TECHNICAL SERVICE BULLETIN

REF.: DRIVELINE/
DIFFERENTIAL
NO.: DL93-001
DATE: NOVEMBER 12, 1993
MODEL: ST, AT

REAR AXLE BEARING

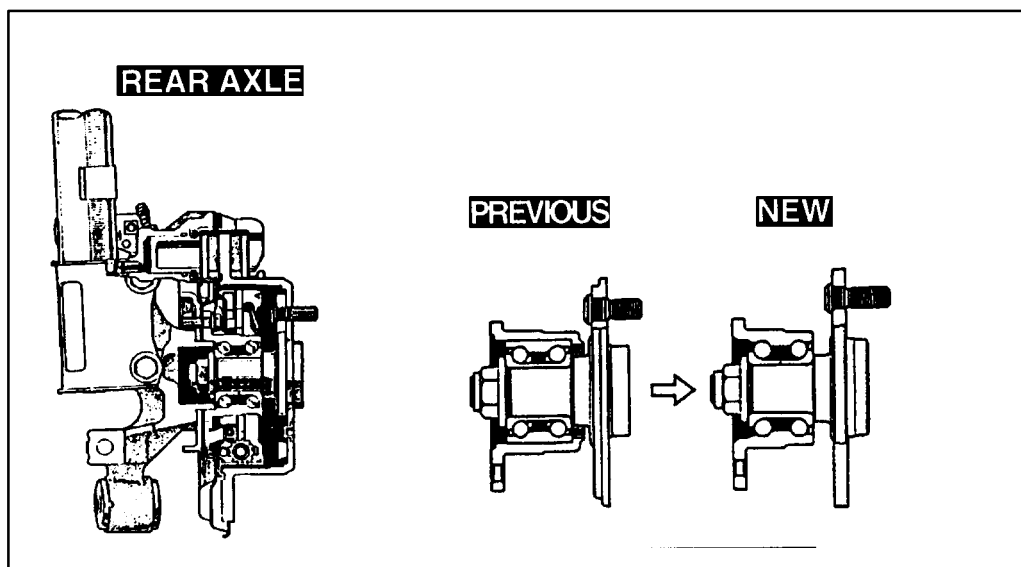
For parts standardization, the rear axle bearing has been changed as shown below.

Because the outer race has been incorporated into the hub, wheel bearings are no longer available as separate replacement parts. The entire hub/bearing assembly must be replaced.

The new style Rear Axle Hub and Bearing Assembly can be used on all ST and AT Celicas. The previous part number Rear Axle Bearing can be used only on vehicles built before the production change.
